PLANNING APPLICATION NUMBER:P10/0149

Type of approval sought	Full Planning Permission
Ward	AMBLECOTE
Applicant	Mr S. JANSCO
Location:	LAND ADJACENT, 2, LORRAINER AVENUE, CLOCKFIELDS, BRIERLEY HILL, WEST MIDLANDS, DY5 3FH
Proposal	DEMOLITION OF DETACHED GARAGE AND ERECTION OF 1 NO. DWELLING AND DETACHED GARAGE
Recommendation Summary:	APPROVE SUBJECT TO A 106 AGREEMENT

S. JANSCO ESQ
 PROPOSED HOUSE
 land adjacent to
 2 LORRAINER AVENUE,
 CLOCKFIELDS, BRIERLEY HILL
 SKETCH SCHEME 2
 09:67:02B

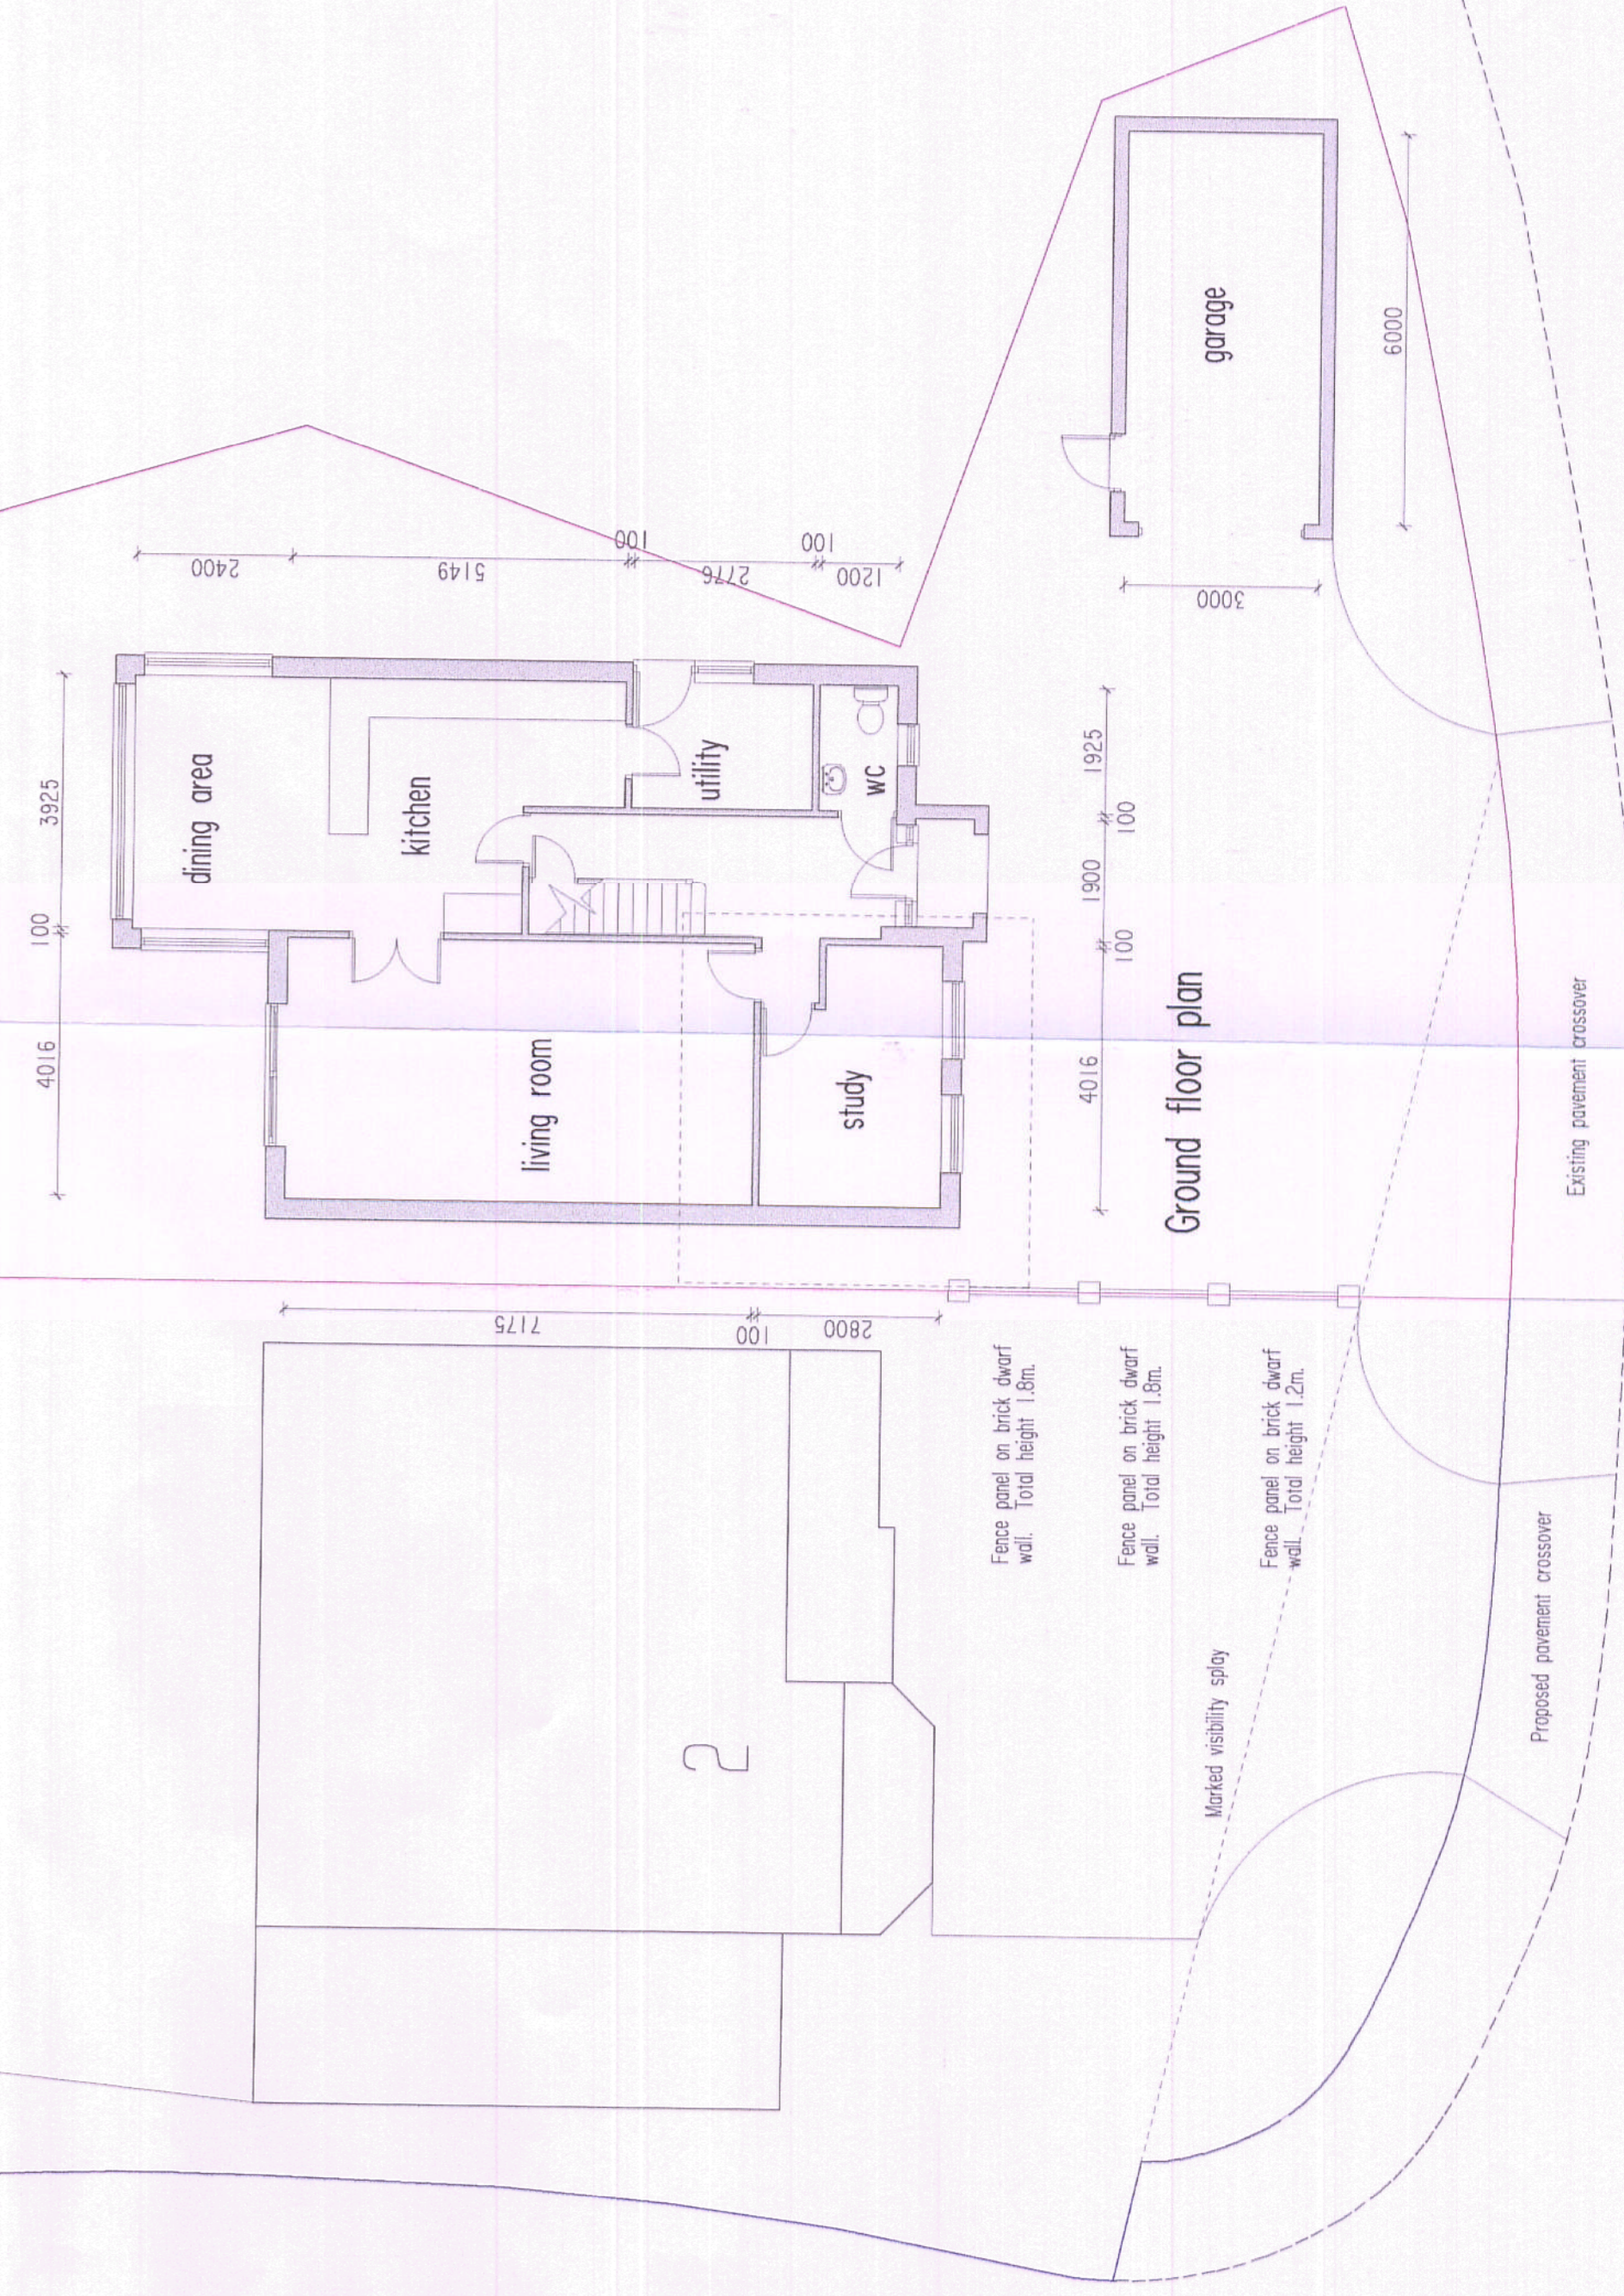
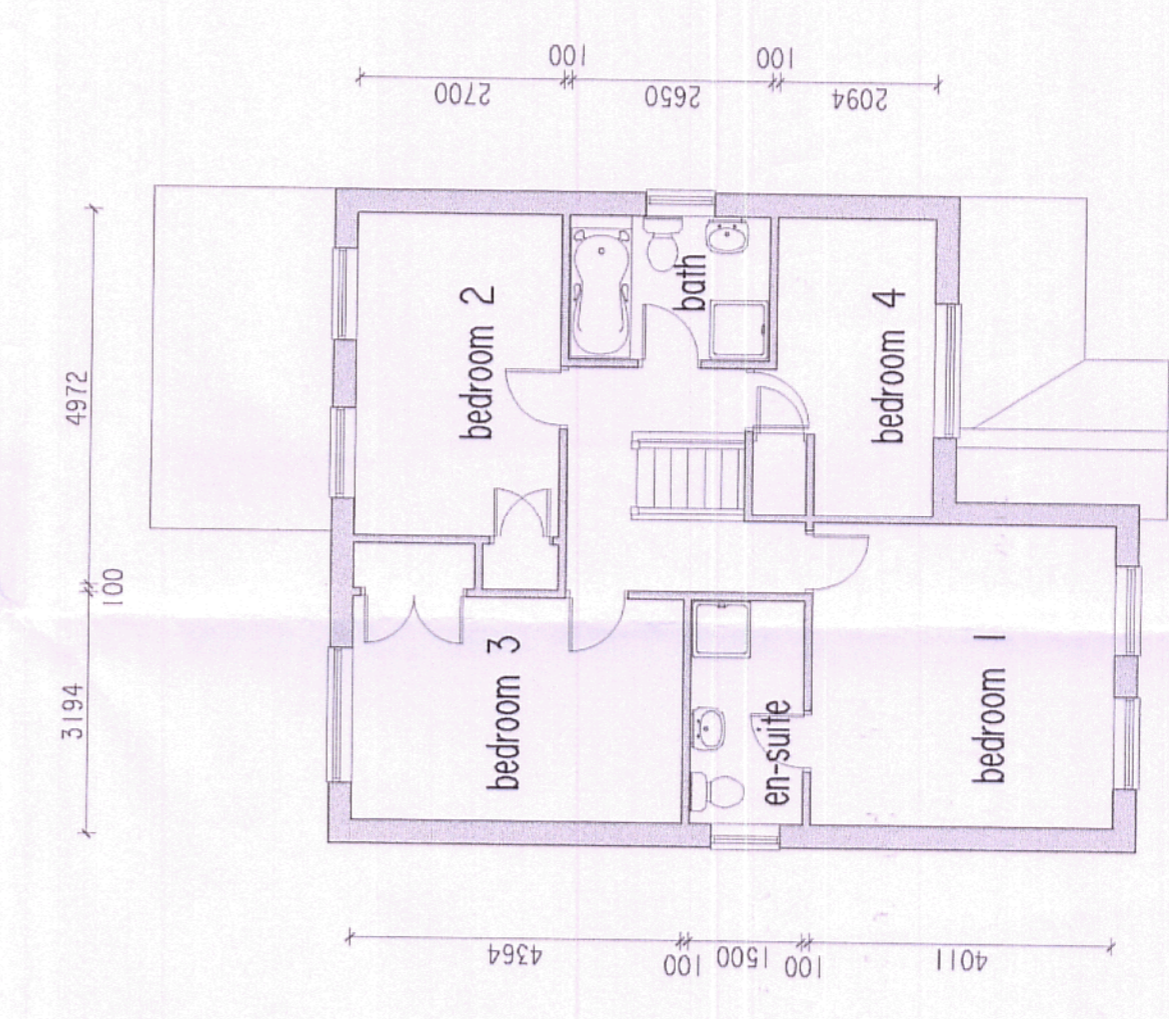
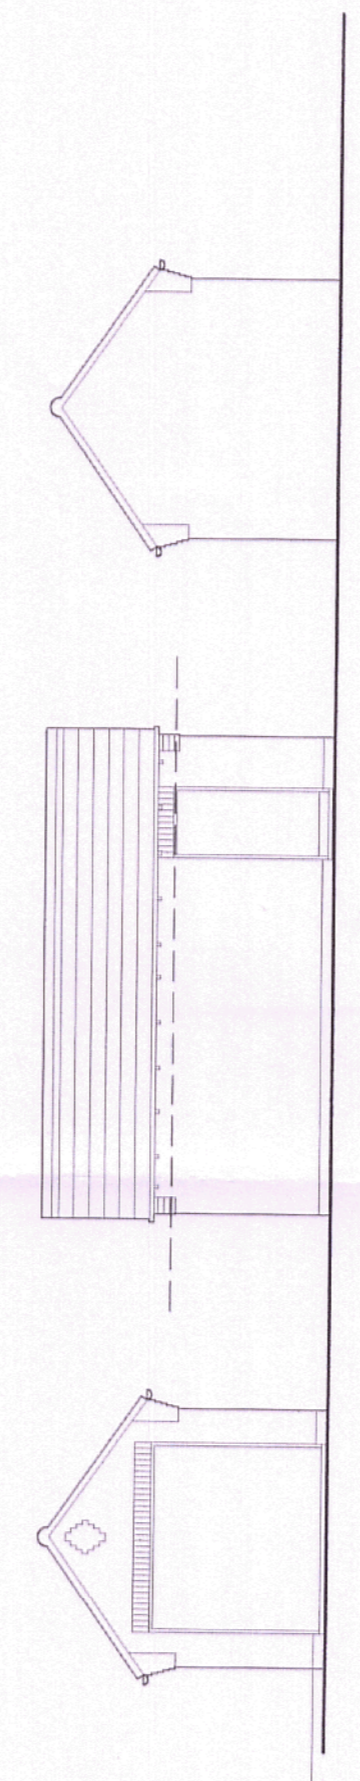
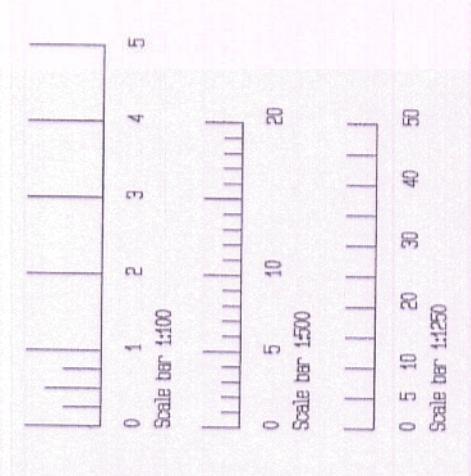
- 9 Group Engineer (Development) – no objections, subject to the depth of the garage being increased to 6 metres, and a revised parking layout in front of the host dwelling – *amended plans have been received, in part to address this issue.*
- 10 Head of Environmental Health and Trading Standards – no objections received.

- 17 Amended plans have been submitted showing a reduction in the height of the ridgeline, enabling the proposed dwelling to be only marginally higher than

- 23 Amended plans have been received showing a reduction in the scale of the proposed garage, including its re-siting further away from the shared boundary with 1 Lisko Close (and the retention of the conifer hedge there). It is considered that this will help prevent the garden of no. 1 being hemmed in significantly by the proposed development.

The Group Engineer has recommended that the parking arrangements for both the host and proposed dwellings be revised so as to properly accommodate appropriate levels of off-street parking: it is recommended that the drive be increased at the host dwelling to enable 2 cars to be able to be parked side by side, and that the garage at the proposed dwelling be increased in depth to 6 metres.

- 24 Furthermore, a condition is recommended to ensure that the bathroom window on the facing side elevation of the proposed dwelling is obscure glazed and that no further windows are installed on that elevation without an assessment of a planning application.

31 Amended plans have been received to show the garage increased in depth to 6 metres, and 2 other spaces clearly marked out for the proposed plot, along with the provision of 3 spaces at the front of the host dwelling. Given this, it is considered that no undue impact on highway safety will arise.

7. The window shown on the western elevation of the dwelling hereby approved (side elevation to the shared boundary with the dwellings fronting Lisko Close) shall be obscure glazed and no additional openings shall be formed in that elevation of the dwelling without the prior written approval of the local planning authority.
